SUBJECT: DEMONSTRATION / DELIVERY HOLD Safety Recall 08S03:
Certain 2007 - 2008 Model Year Expedition and Navigator Vehicles
Interior Side Door Handle Spring Replacement

DEMONSTRATION / DELIVERY HOLD Safety Recall 08S03
Certain 2007 - 2008 Model Year Expedition and Navigator Vehicles
Interior Side Door Handle Spring Replacement

CERTAIN 2007-2008 EXPEDITION AND NAVIGATOR VEHICLES — INTERIOR SIDE DOOR HANDLE SPRING REPLACEMENT

FIGURE 5

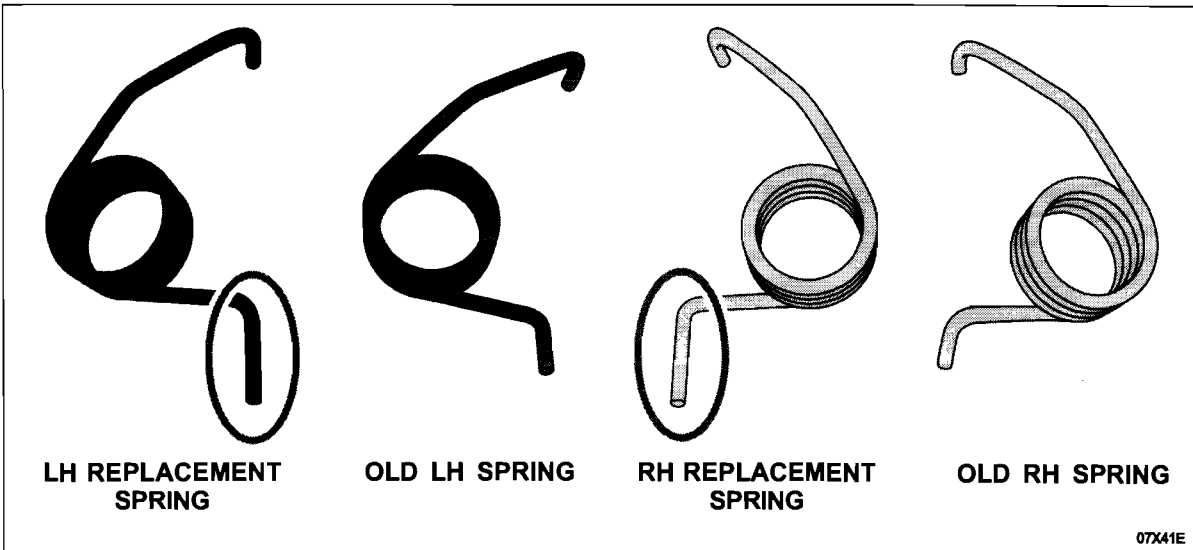
5. NOTE: The interior side door handle spring retainer may be cracked or missing. See Figure 6 for the location of the spring retainer. The **new** re-designed spring has a longer leg and does not need the retainer to function. The door handle does not need to be replaced, even if the spring retainer is damaged. See Figure 5 for example of re-designed spring.

Position the **new** interior side door handle spring (LH is green, RH is gray) into the interior side door handle and install the interior side door handle spring pin. The **new** spring can be installed into the retainer even if the retainer is damaged or broken. See Figure 6 for example of correct assembly.
